# Betula Apartments

## DRAFT RECOMMENDATION PACKET

3037444-LU

# RESPONSES TO RECOMMENDATION

## rec 2. Provide privacy for ground level units with added landscaping

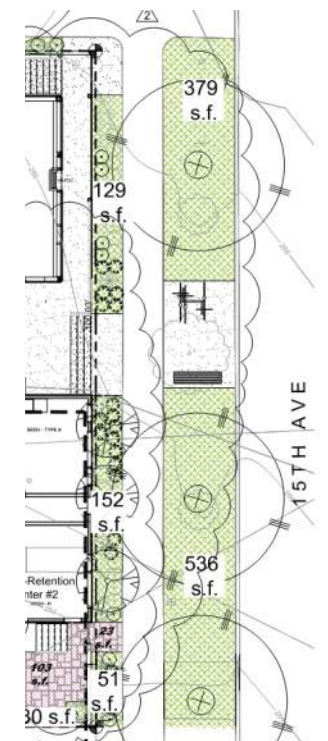
EDG - lack of plantings on 15th Ave.

Per recommendation, plantings were added along 15th Ave. Major MUP revision has not affected the previously approved planting plan.

**rec 4. Expand window depth to min. 6" and incorporate shading projections into facade**

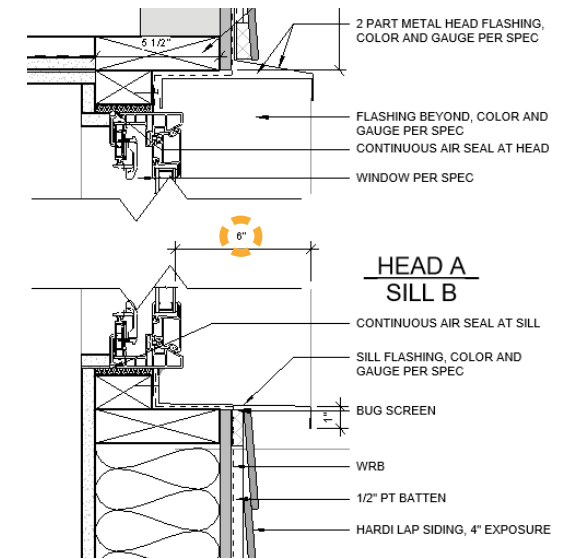
EDG - flat facade

Per recommendation, window flashing depth was increased to 6".

For the "major MUP revision", inspired by support from public comment, balconies have been introduced on the south face with the added benefit of solar shading.

**rec 5. Revise east courtyard planter to make room for site furniture**

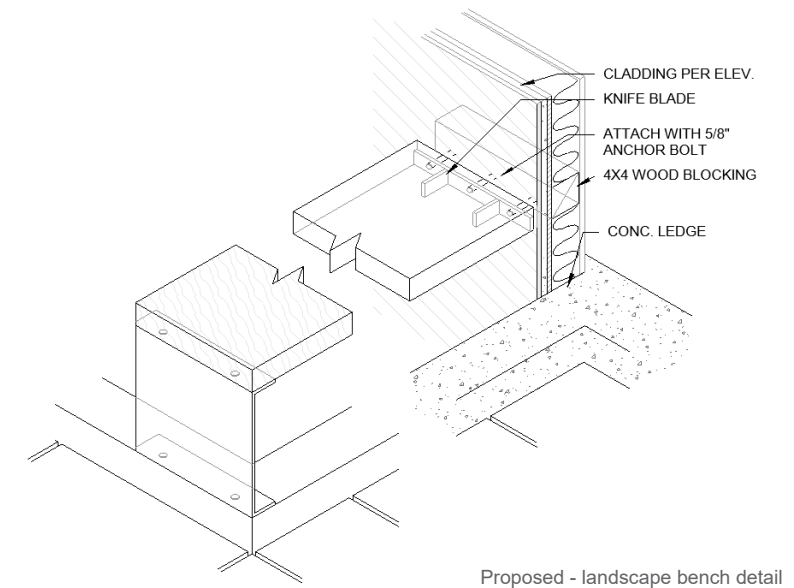
EDG - panter at east courtyard

The planter has been reduced to make room for a built-in bench integrated into the landscape / hardscape, serving as a waiting area in the courtyard.
